Customer No.: 31561  
Application No.: 10/063,737  
Docket No.: 8727-US-PA

**In The Drawings**

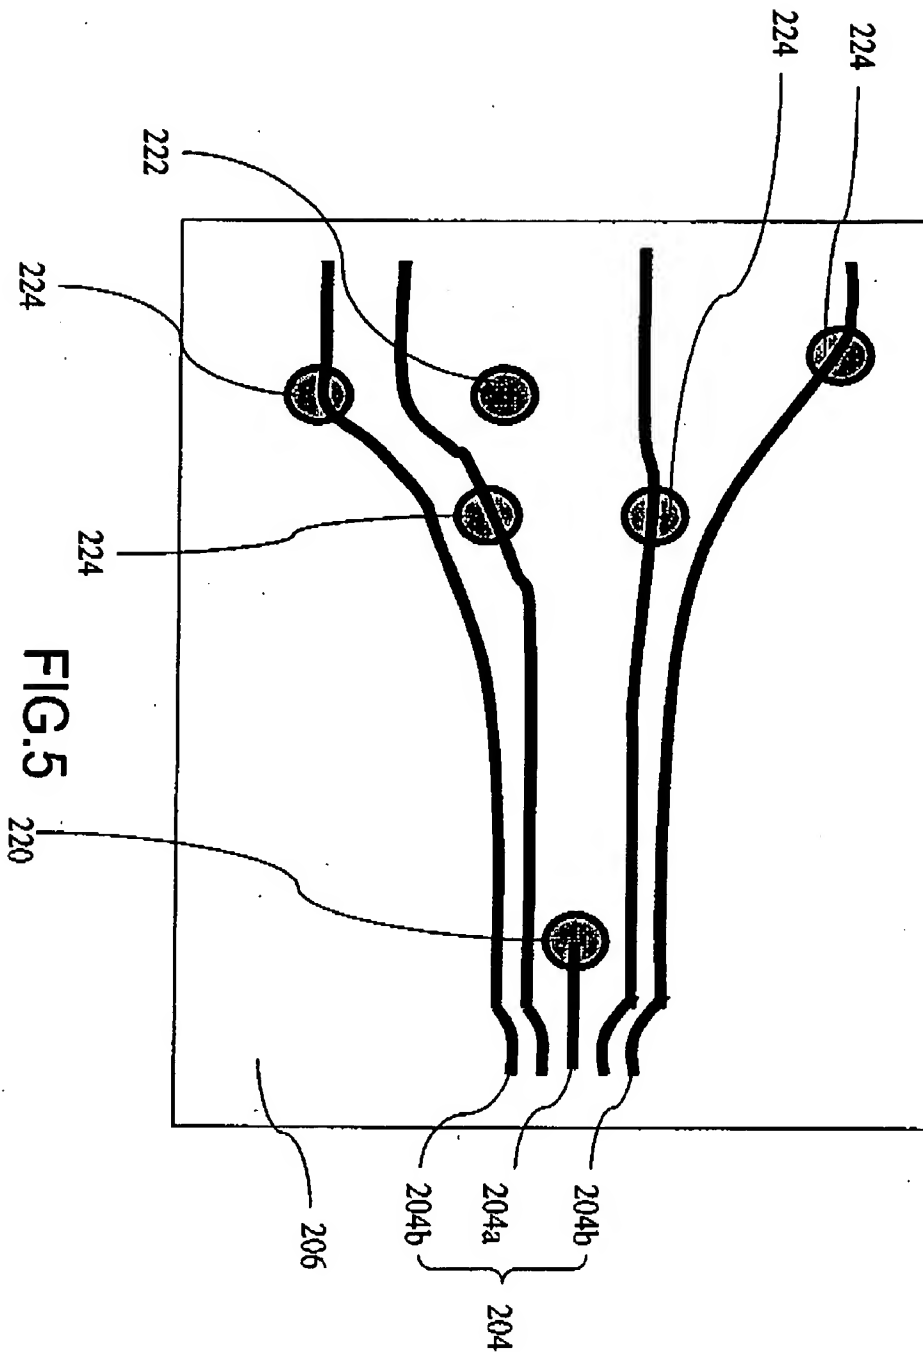
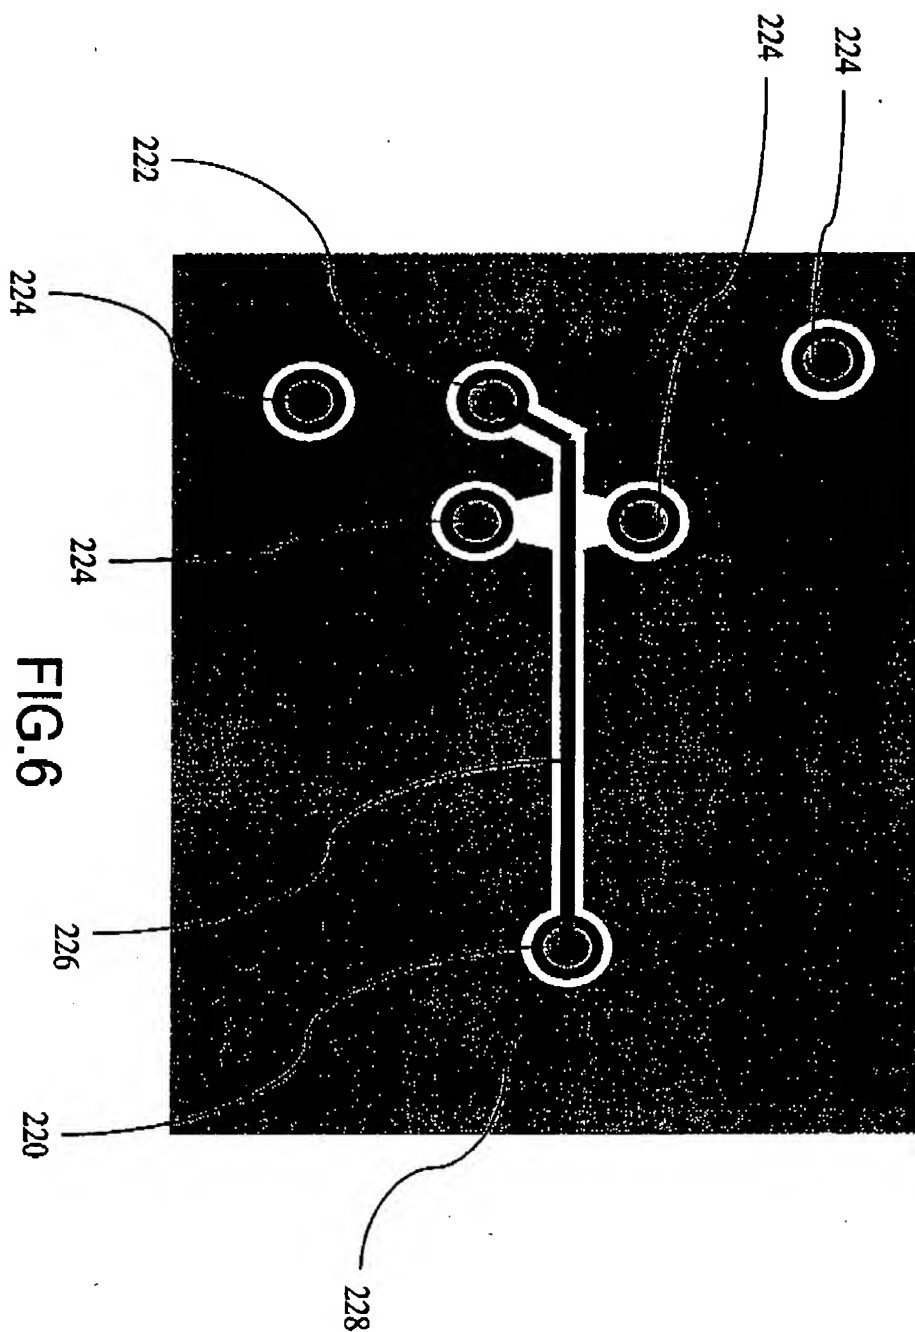
The Applicants have amended FIGs. 5, 6 and 7 for including technique features cited in the previously presented claim 16 and newly added claims 27-33. The technique feature in the claim 27 is described in the embodiments and the definition of a reference voltage, which should be a constant voltage. Therefore, no new matter is added.
